RE: In the Matter of the Establishment of 4901:1-10-10(B) Minimum Reliability Performance Standards for Ohio Power Company.

Enclosed please find Staff's Review and Recommendations in regard to the application filed by Ohio Power Company in Case No. 16-1511-EL-ESS.

# AEP Ohio Standards Application 16-1511-EL-ESS Staff Position

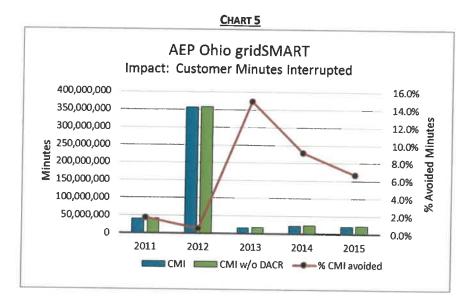
Staff evaluated this data and found that while there has been marked reliability improvement attributable to gridSMART technology, overall impact has been trending downwards for the last three years both in terms of avoided customer interruptions and avoided customer minutes interrupted. This is further illustrated on the following charts:

Staff recommends no adjustment to account for reliability improvements attributable to gridSMART at this time. However, AEP's next standards application should include such a calculation with supporting data to be examined by Staff.

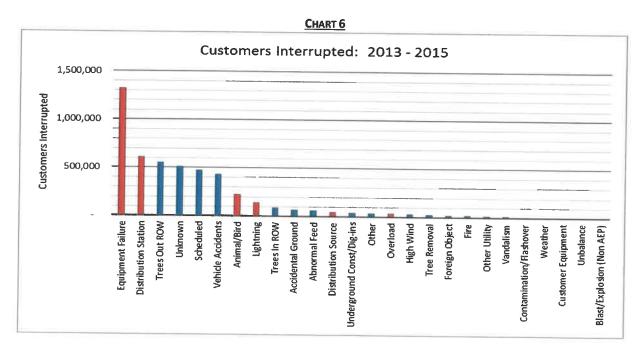
Staff examined outage causes for the last three years and believes that the Company's assessment of which causes within the Company's control (indicated by the red bars below) are most impacted by the DIR is accurate. Additionally, those outage causes impacted by the DIR account for approximately 50% of customer interruptions.
